ADDENDUM NO. 2

Rochester City School District

Dr. Walter Cooper, School #10

February 28th, 2018

DRAWING "C1002 - EXISTING CONDITIONS PLAN"

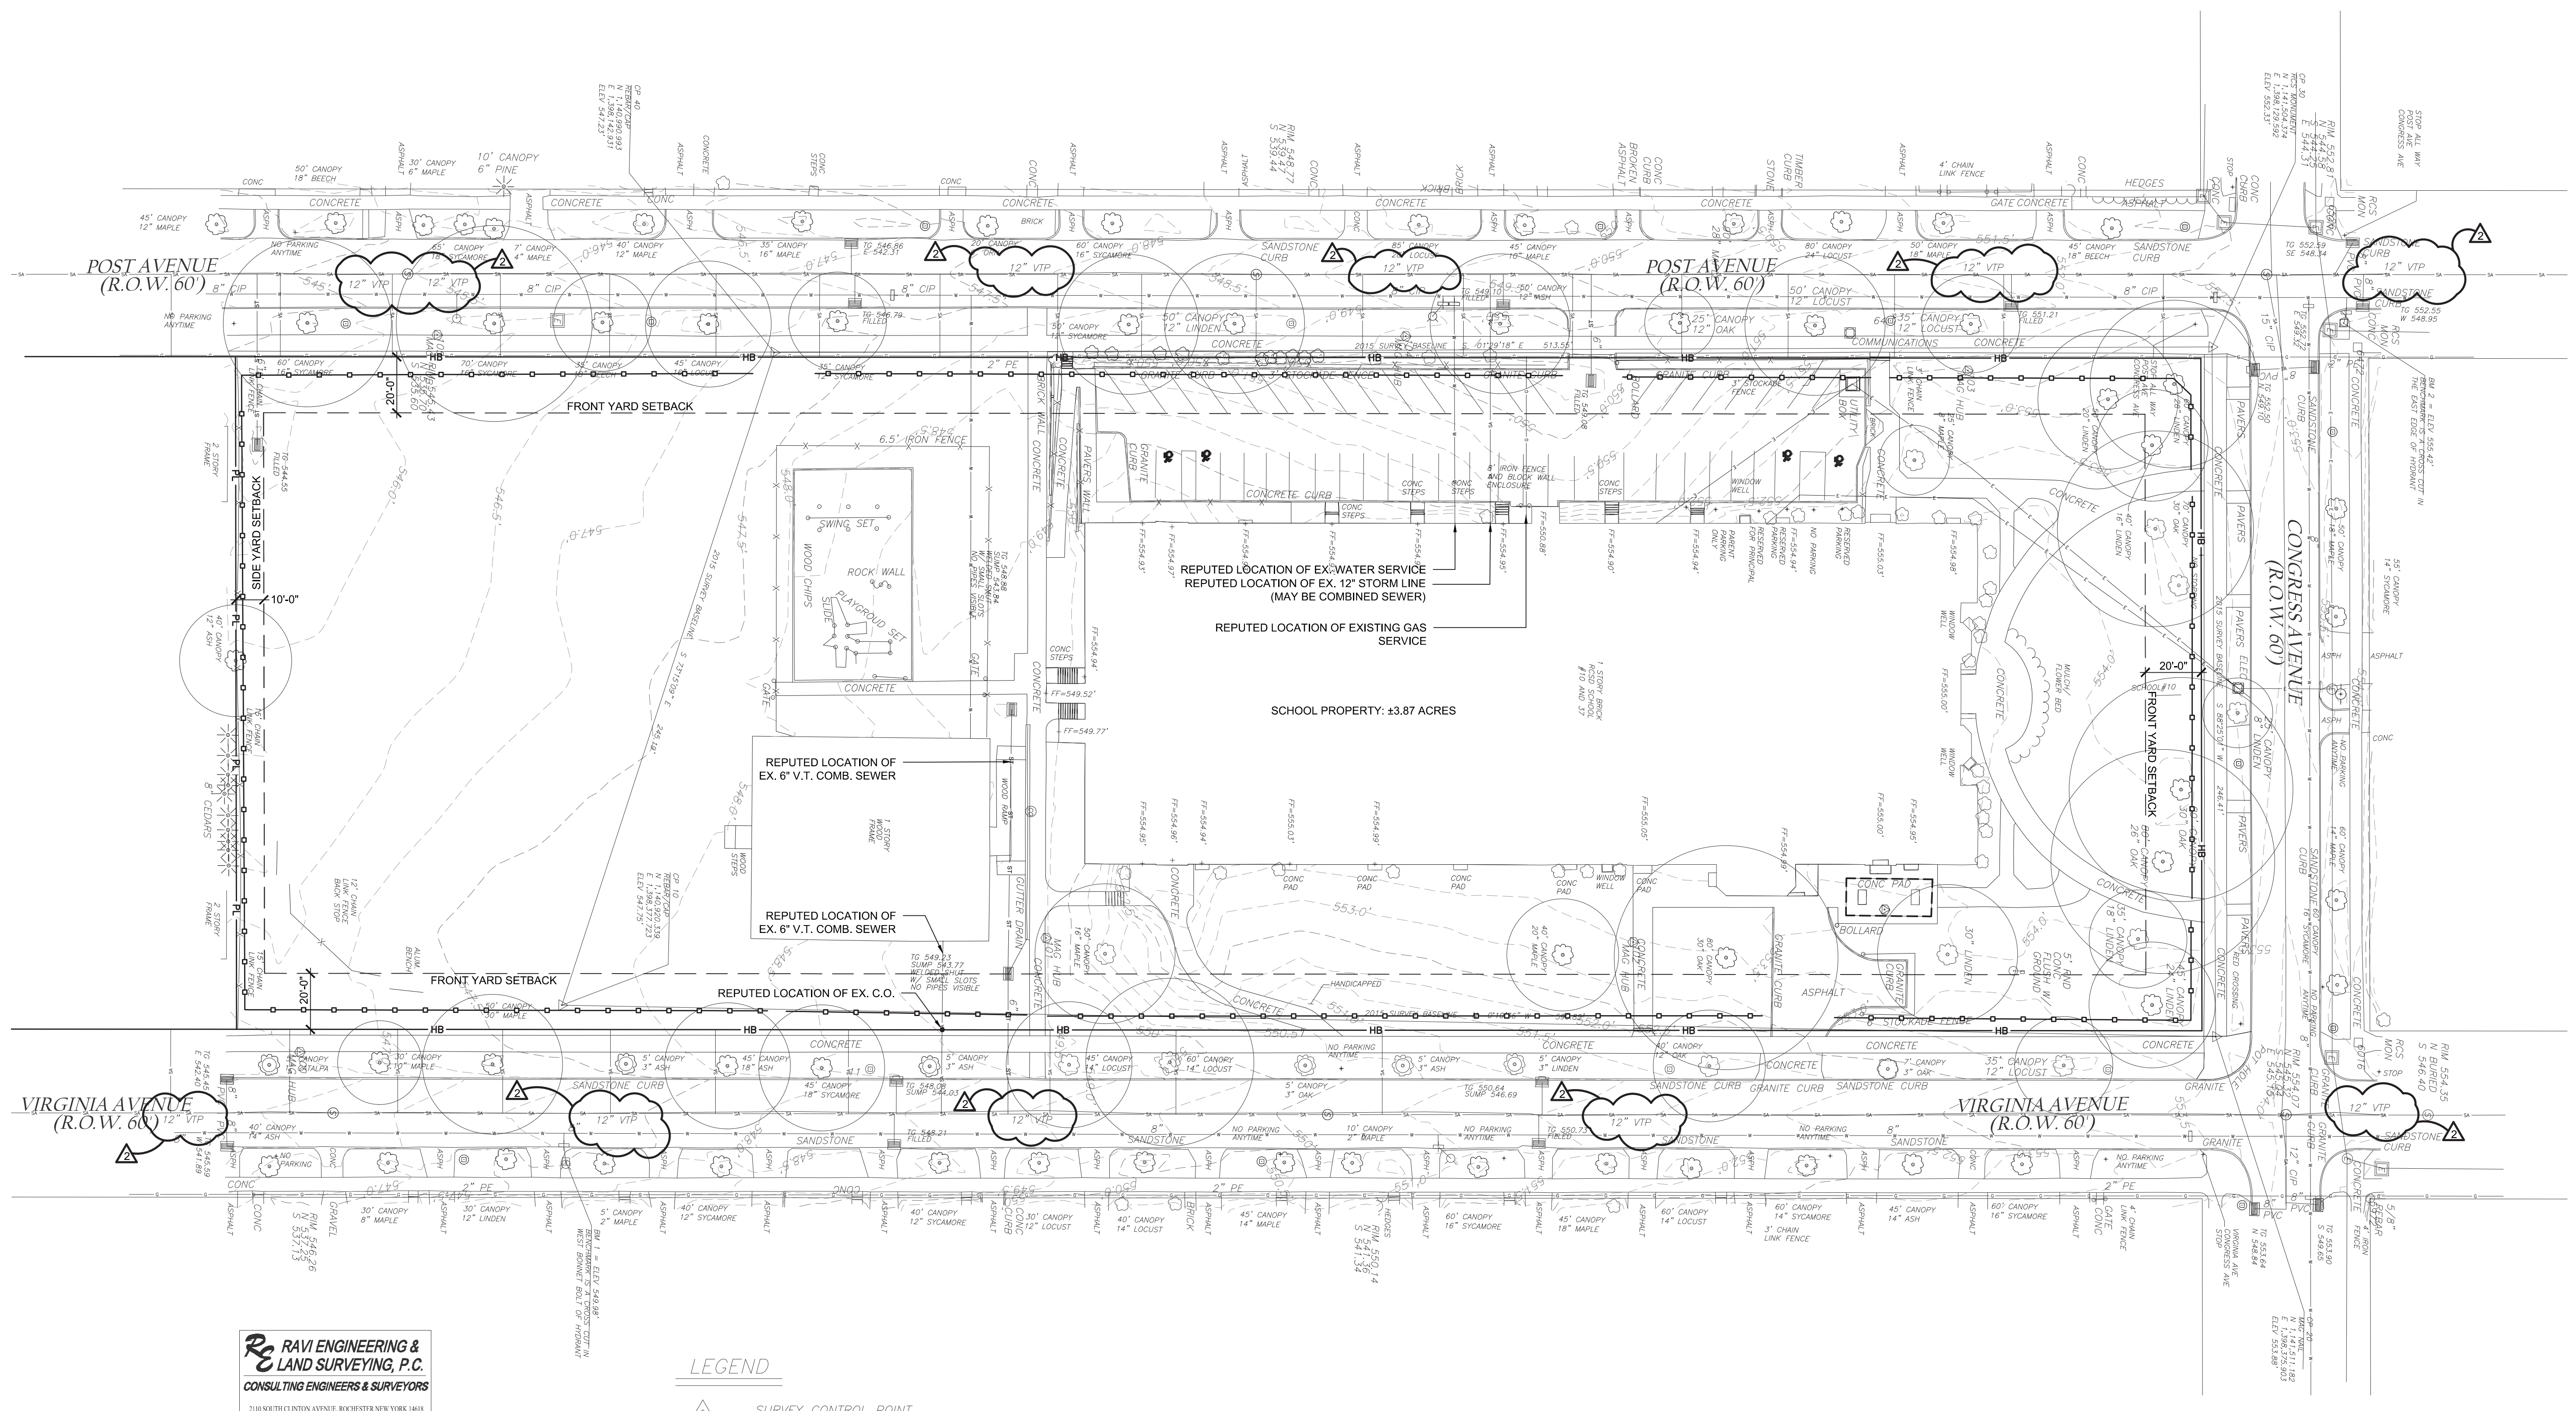
Item AD2-10 **REPLACE** drawing in its entirety with attached "C1002 - EXISTING CONDITIONS PLAN." Revises existing sewer pipe size and material.

DEMOLITION PLAN

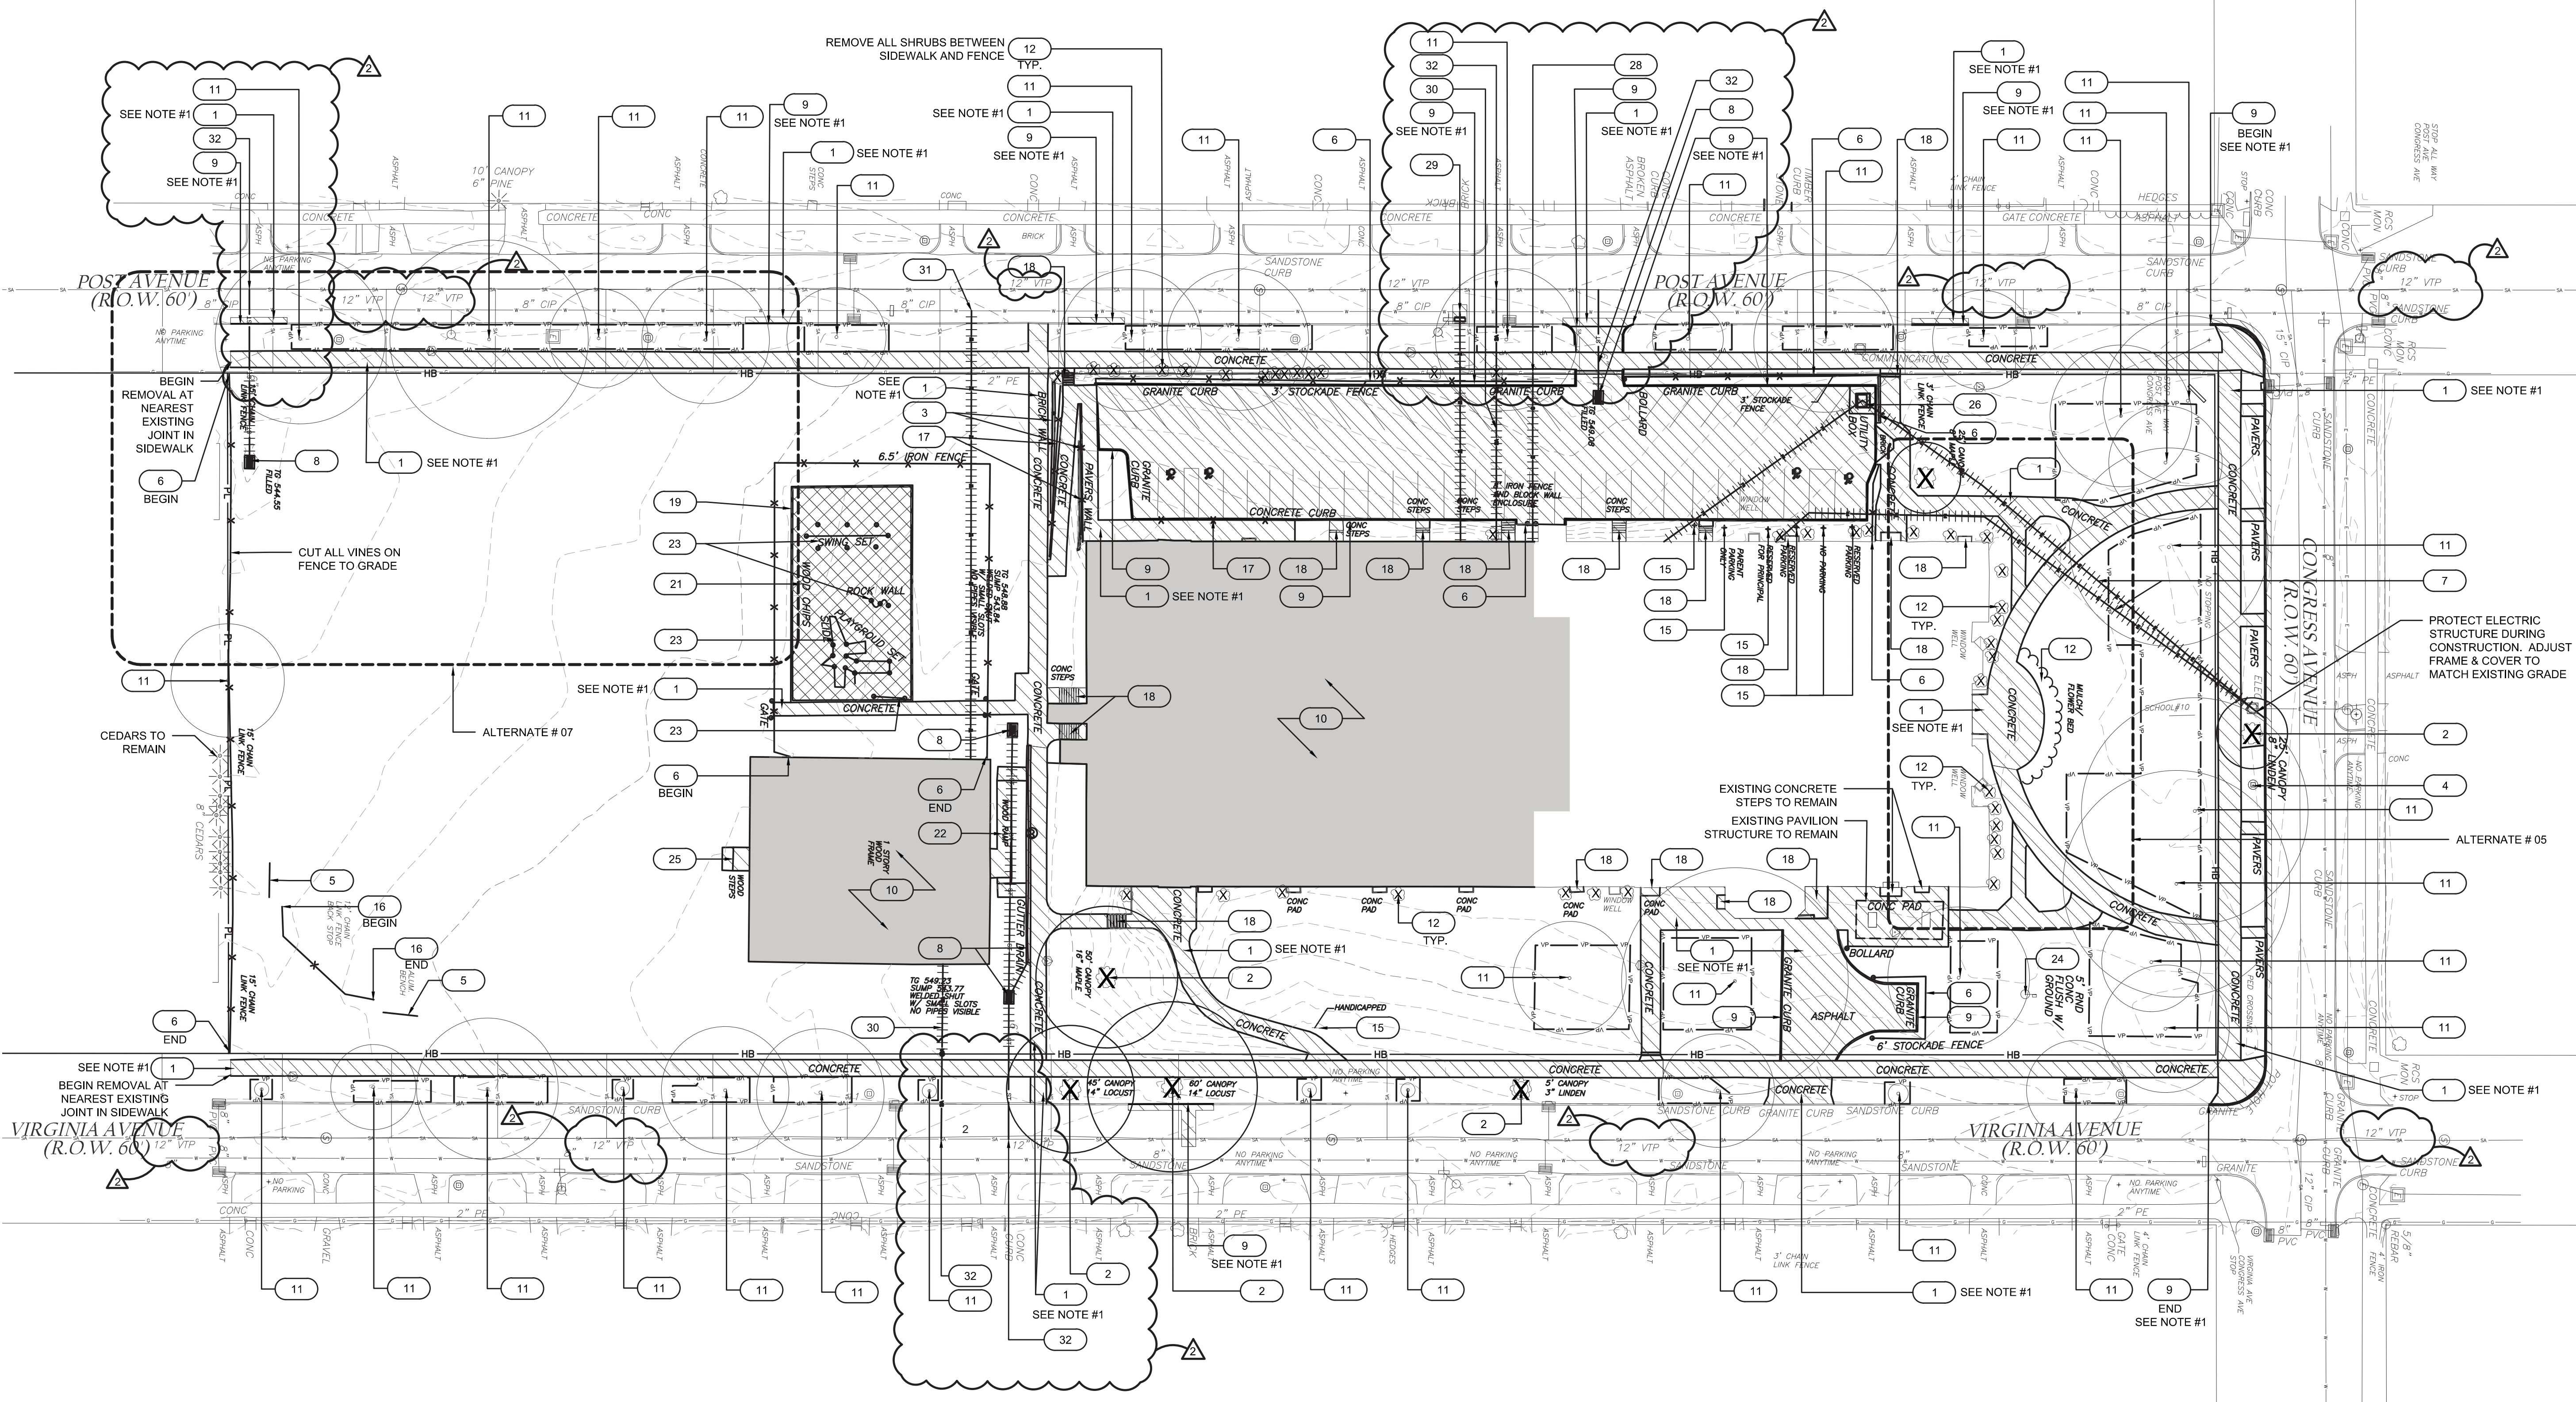
Item AD2-11 **REPLACE** drawing in its entirety with attached "C1004 - DEMOLITION PLAN." Include pipe abandonment in ROW in lieu of pipe removal. Reduce pavement removal associated with abandoned utilities.
